## FORD E4OD "UPDATE HANDBOOK"

### INDEX

Figure 22

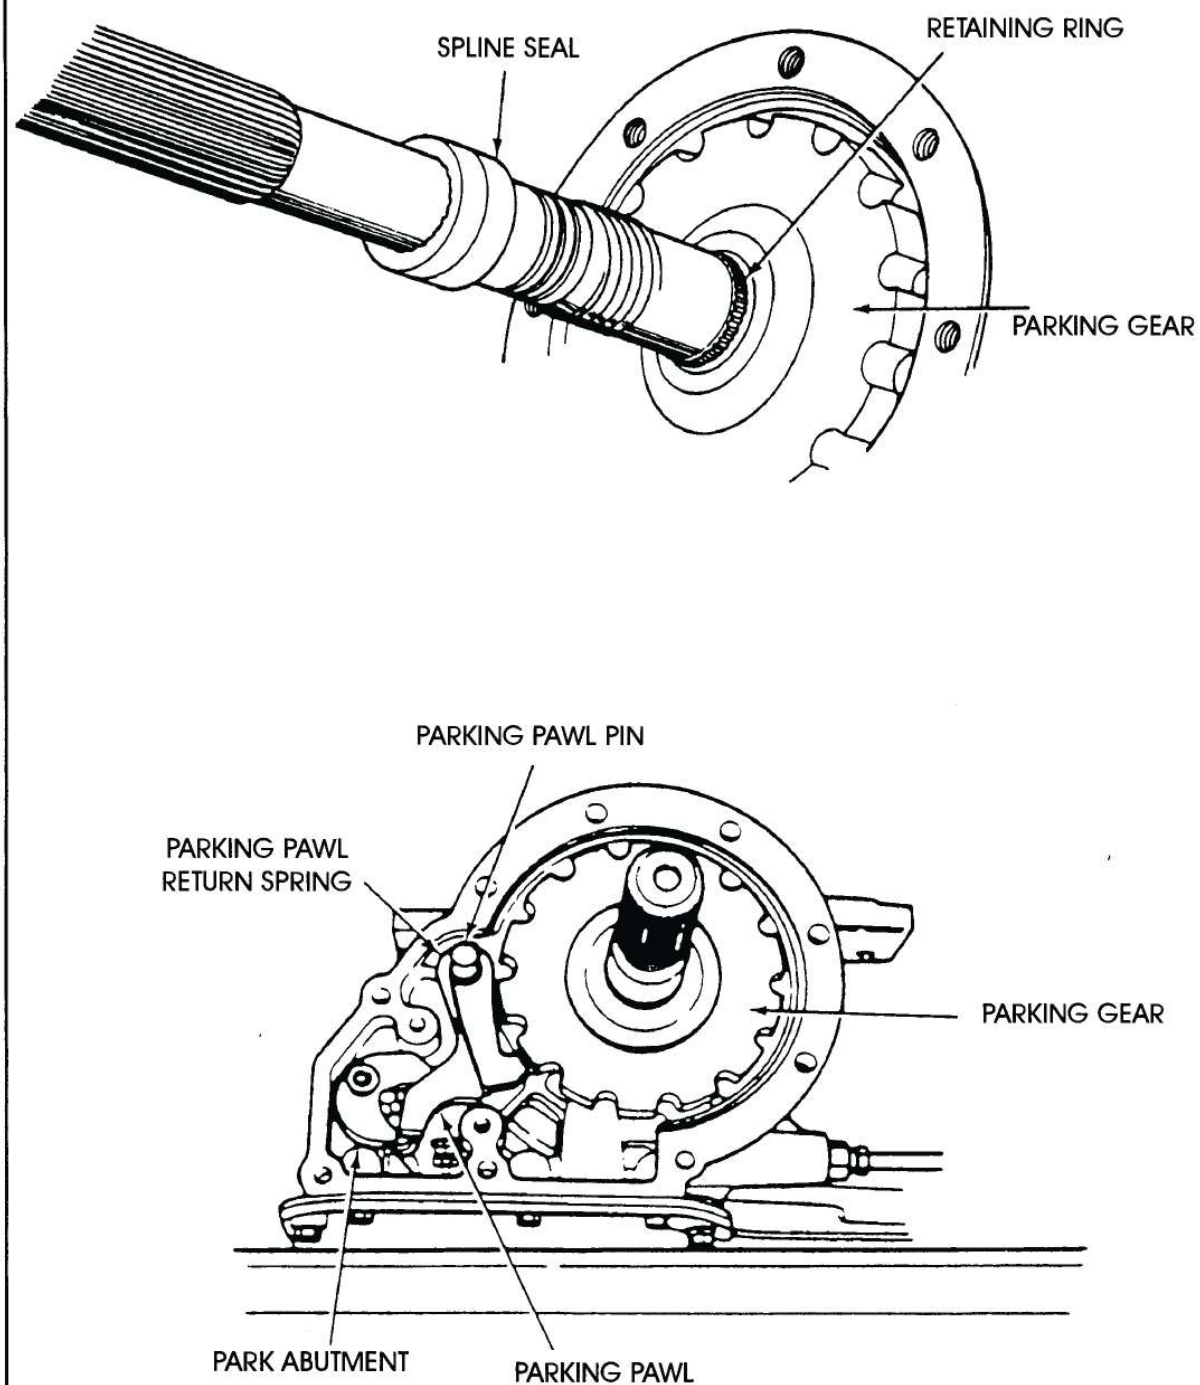
**CAUSE:** The cause may be a broken snap ring on the output shaft, allowing the parking gear to move rearward, and then the parking pawl cannot engage into the parking gear. Refer to Figure 22.

**CORRECTION:** There is now available a new service package, under OEM part number F0TZ-7A040-A, that includes a new design extension housing with a new "Boss" cast into it to prevent the parking gear from moving rearward in case the snap ring breaks (See Figure 24). The service package also includes a new "*high strength*" snap ring, and a snap ring installation aid, as shown in Figure 25.

Figure 26  
AUTOMATIC TRANSMISSION SERVICE GROUP

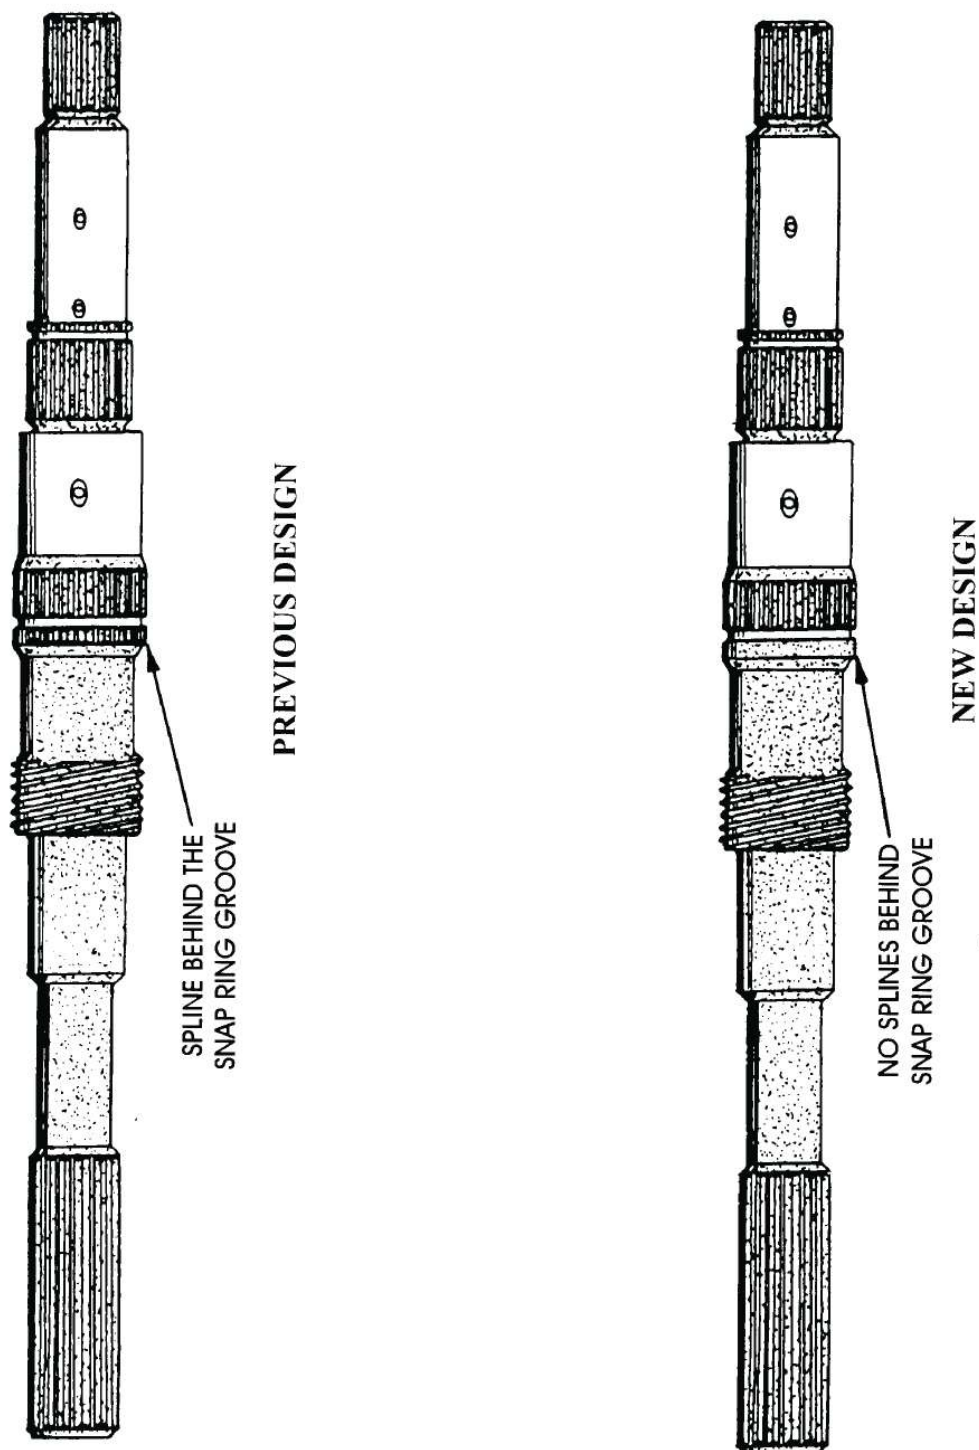
The Output Shaft has also been redesigned for 1990 and later models, with the splines removed from behind the parking gear snap ring groove, which creates an increased shoulder for the snap ring, and helps prevent the snap ring from breaking. Refer to Figure 26.

Figure 27

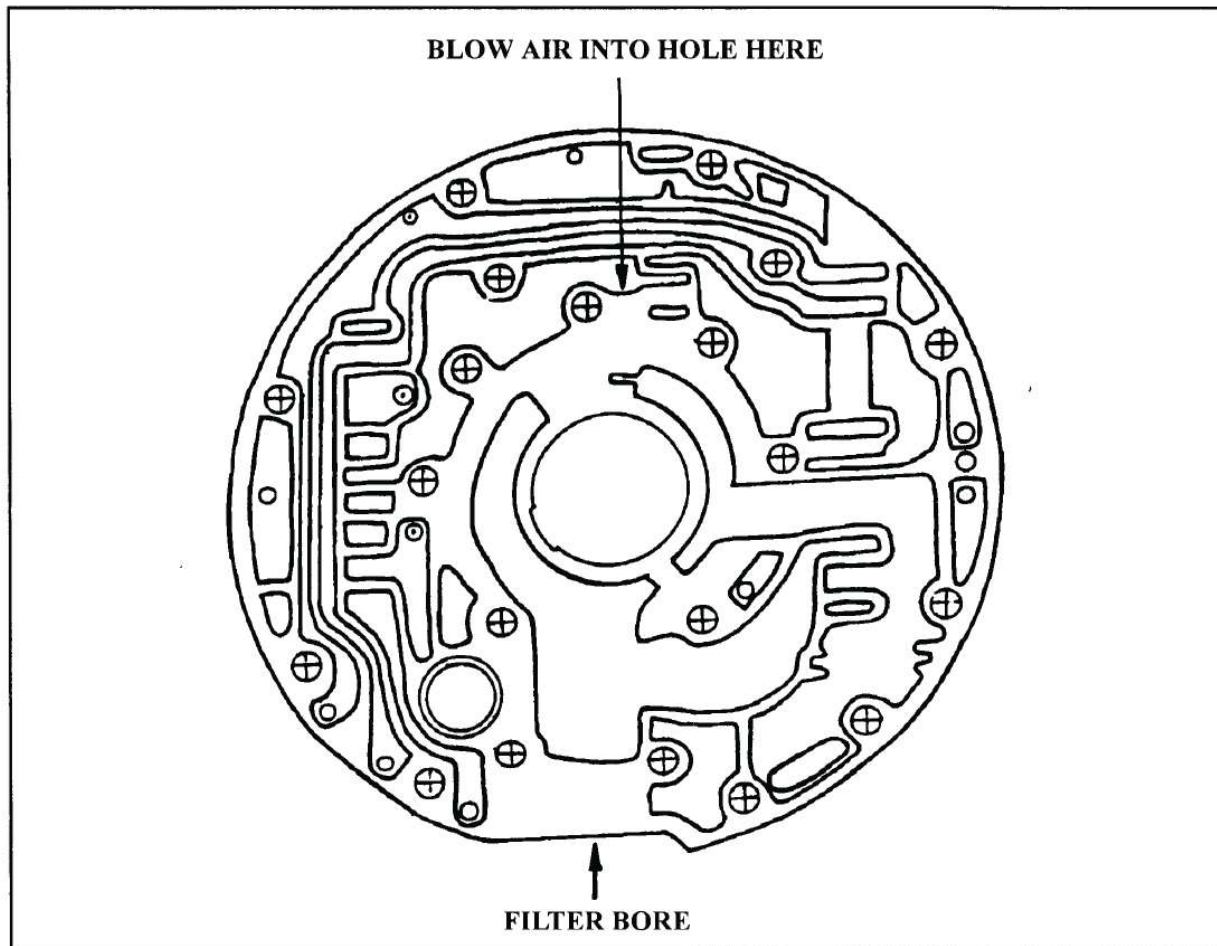
**CORRECTION:** To check for restriction, blow air into the hole in pump cover as shown in Figure 27, and air should exit from the holes in rear of stator shaft, as shown in Figure 28. If the passage is restricted or blocked the orificed cup plug must be removed, the plastic valve assembly replaced, and the passage thoroughly cleaned (See Figure 28)

Figure 29

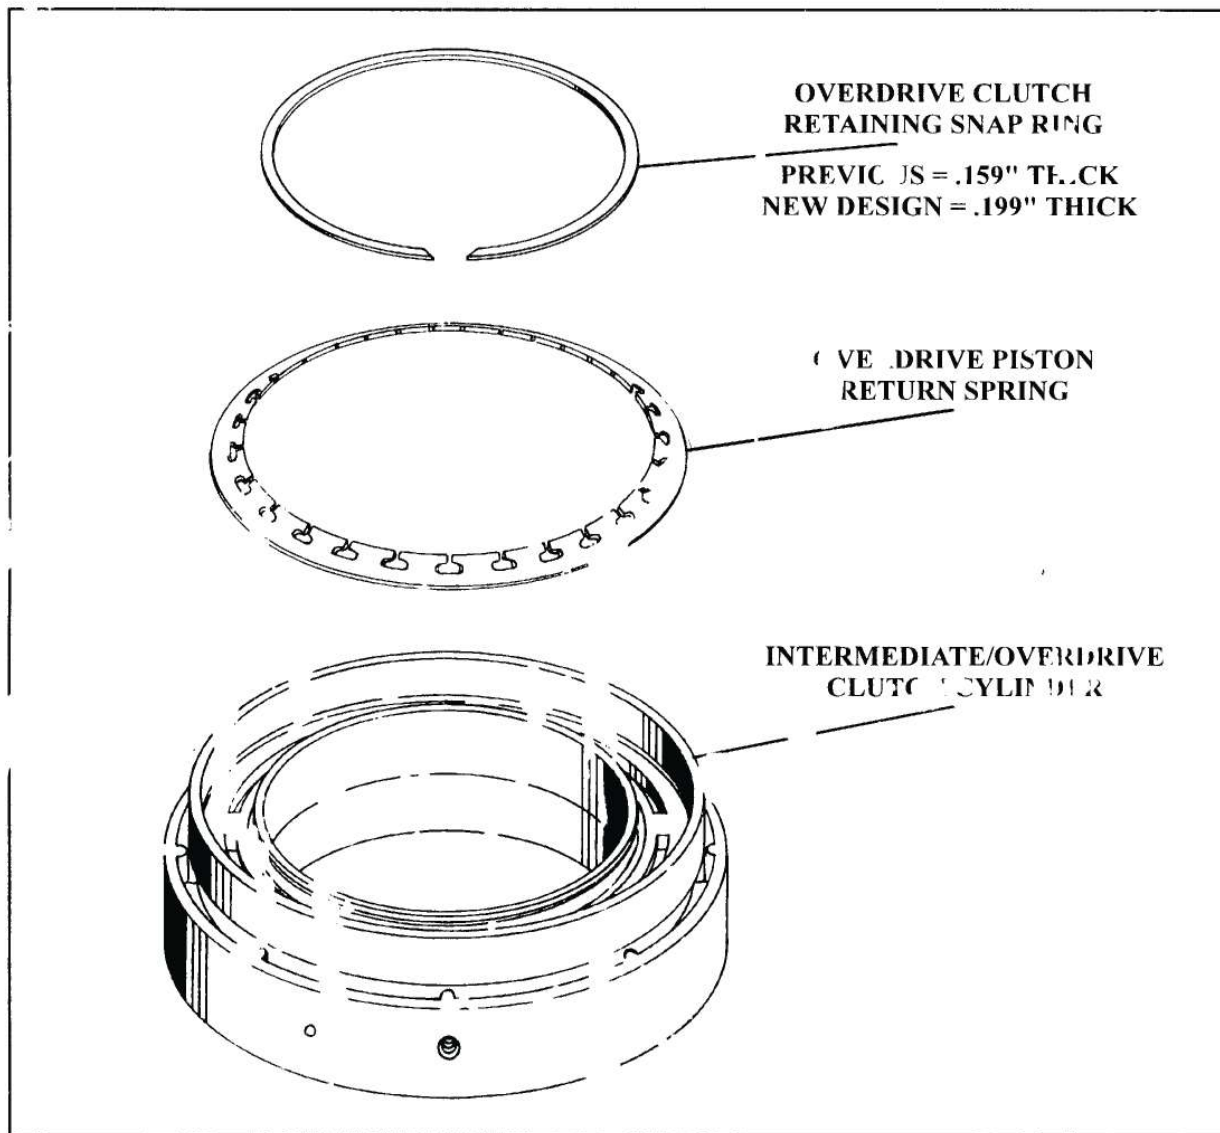
**COMPLAINT:** Harsh 3-4 shift, and/or, upon transmission disassembly the Overdrive Clutch retaining snap ring is dislodged from the groove (See Figure 29).

**CAUSE:** Insufficient tension on the Overdrive Clutch Snap Ring.

**CORRECTION:** Install a new design (Thicker) snap ring that has more tension than the previous design. The new design snap ring is .199" thick and the previous design is .159" thick, as shown in Figure 29.

Figure 30

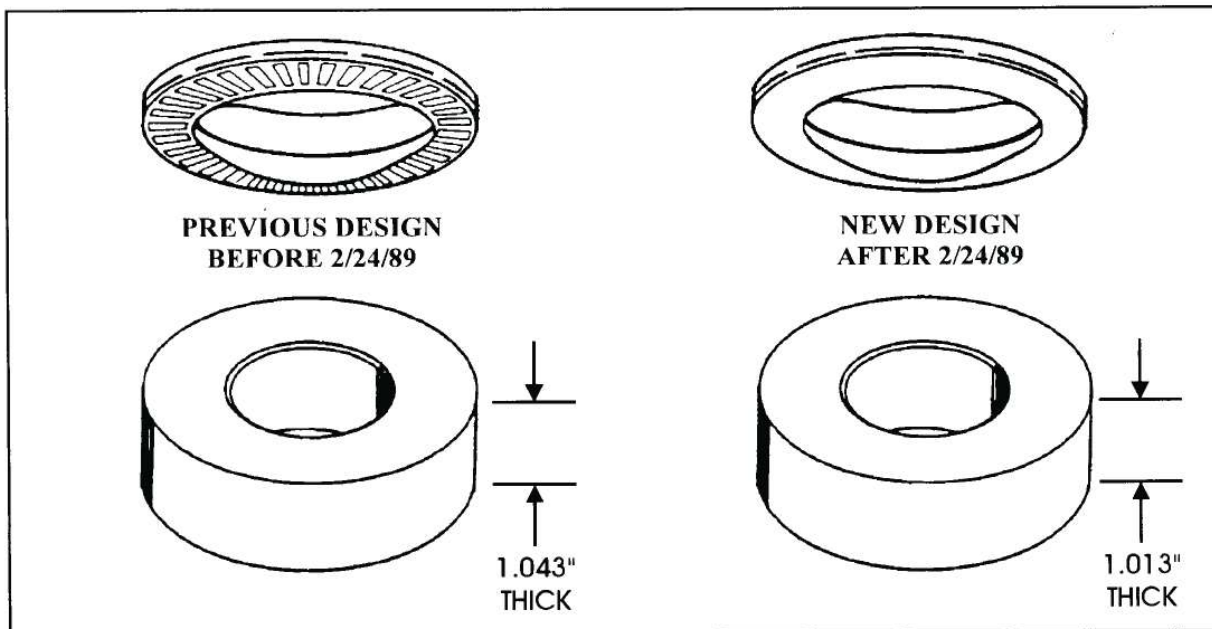
- (1) **LOW ROLLER CLUTCH INNER RACE** - As of 2/24/89, the Low Roller Clutch Inner Race height has been reduced by .030" to accommodate a revised hub to race thrust bearing. The previous inner race height was 1.043" and the new design is 1.013", as shown in Figure 30.
- (2) **HUB TO RACE THRUST BEARING** - The previous thrust bearing was a **2 Piece** (open face) design, and the new design is a **3 Piece** (closed) design bearing. The thickness of the previous 2 piece thrust bearing is .110" thick, and the new design 3 piece bearing is .140" thick, so that it is compatable with the new thinner inner race (See Figure 30).

Figure 31

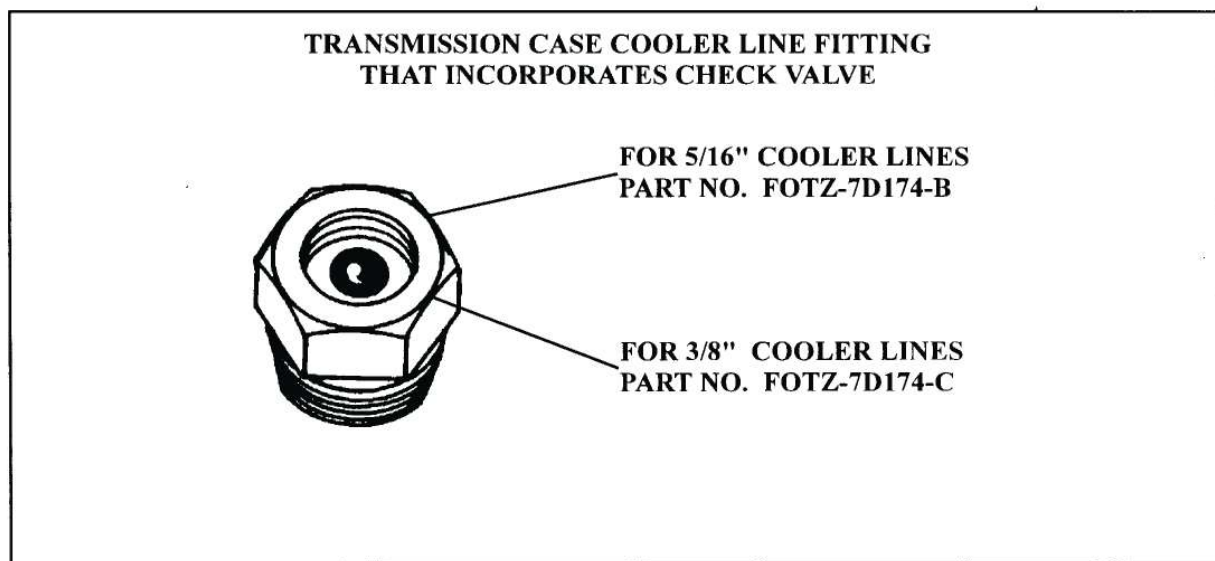
**CHANGE:** Beginning in mid-year of the 1990 model year, Ford Motor Company incorporated a check valve into the rear cooler line fitting as shown in Figure 31.

- (1) **REAR COOLER FITTING** - Now incorporates a check valve inside the cooler line fitting, as shown in Figure 31. There are two different size fittings, one for 3/8" cooler lines and one for 5/16" cooler lines.

Figure 33

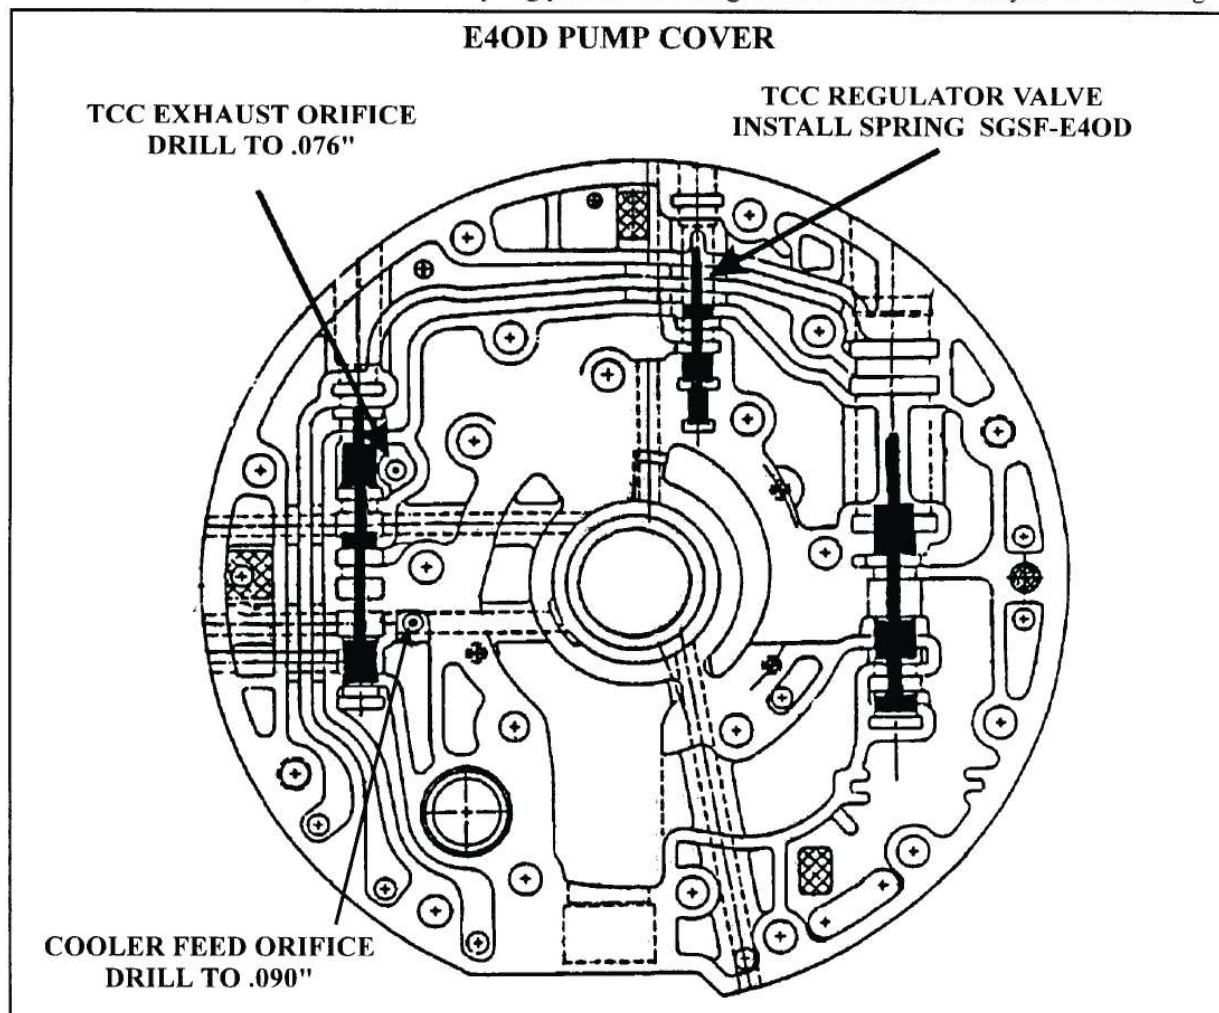
**CORRECTION:** Replace the converter clutch regulator valve spring, located in the pump cover with a "SGSF E4OD" shudder fix spring as shown in Figure 33. Also drill the converter clutch exhaust orifice out to .076", as shown in Figure 33. It is also recommended to drill out the cooler orifice to .090" for increased lube flow, as shown in Figure 33.

**NOTE:** Ford Motor Company replaced this spring with a heavier spring in 1992 and later models, so ensure the spring you are installing is *heavier* than the one you are removing.

Figure 34

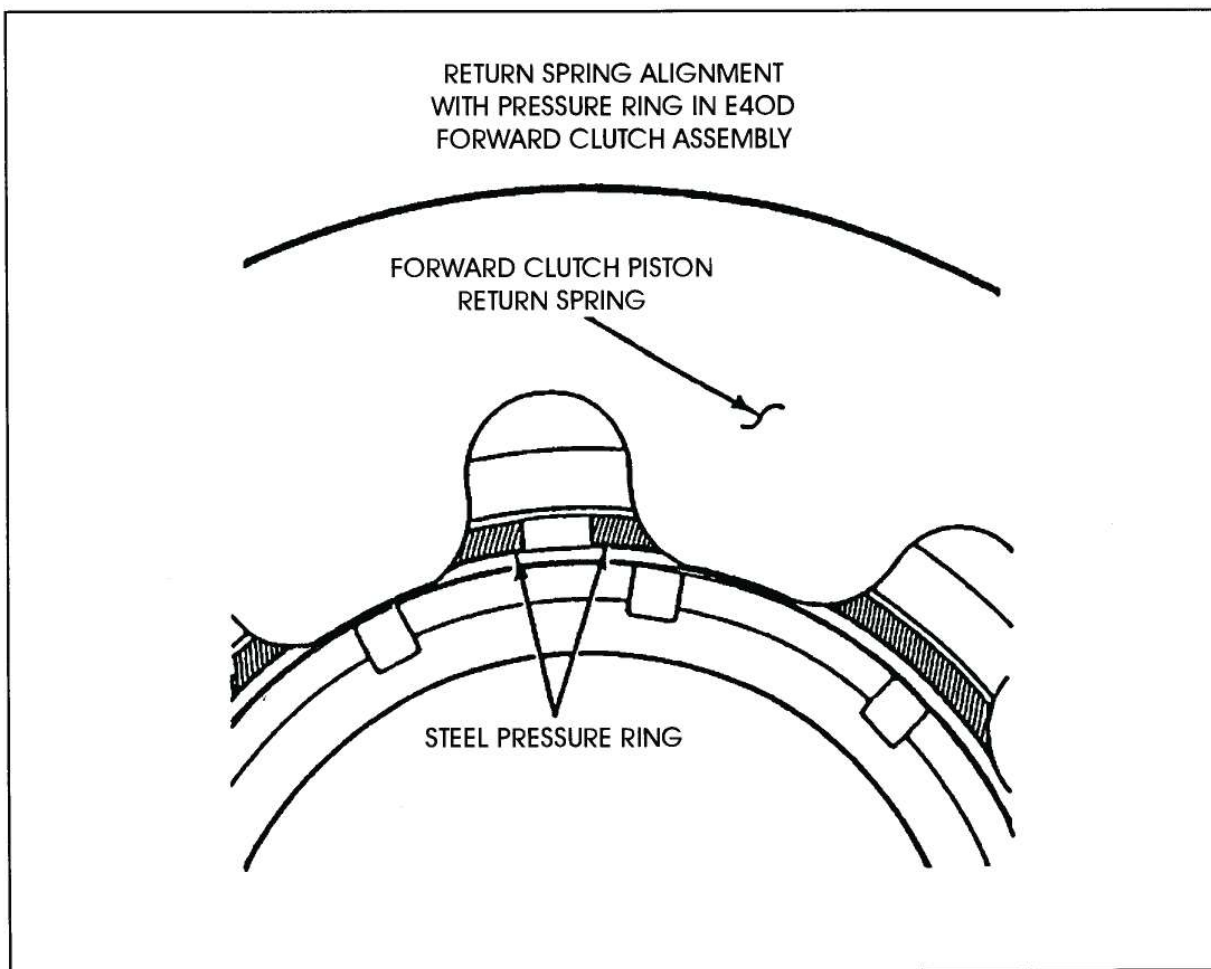
**CAUSE:** The cause may be, improper orientation of steel ring on top of the forward clutch piston, and the forward clutch piston return spring.

**CORRECTION:** Position the forward clutch piston return spring so that both ends of the steel ring are visible within the space between the two adjacent fingers of the return spring as shown in Figure 34.

Figure 35

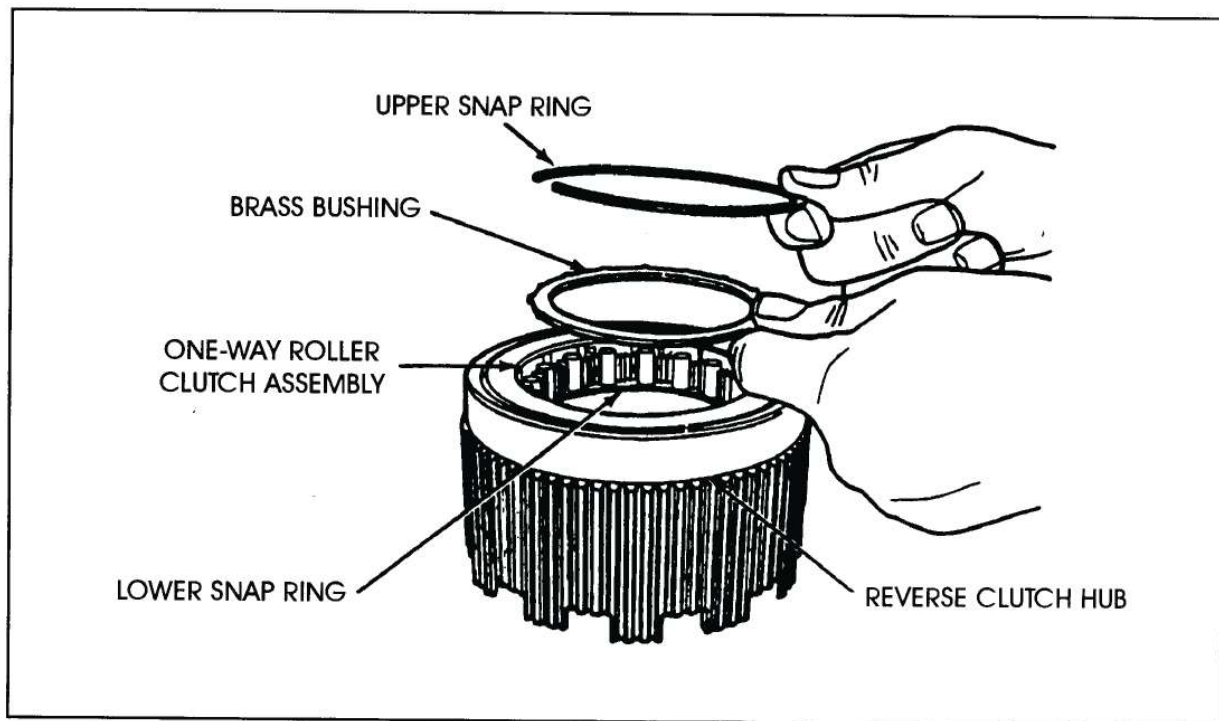
- (1) Remove the upper snap ring, brass bushing, roller clutch assembly, and the lower snap ring, as shown in Figure 35. **Discard all parts removed!**
- (2) Install the New Plastic Cage Low Roller Clutch Assembly through the **rear** side of the Reverse Clutch Hub, with the tabs on the rear edge. Seat the Low Roller Clutch into the Reverse Clutch Hub, and rotate clockwise to seat rollers and lock tabs in place. Refer to Figure 36 for proper installation.
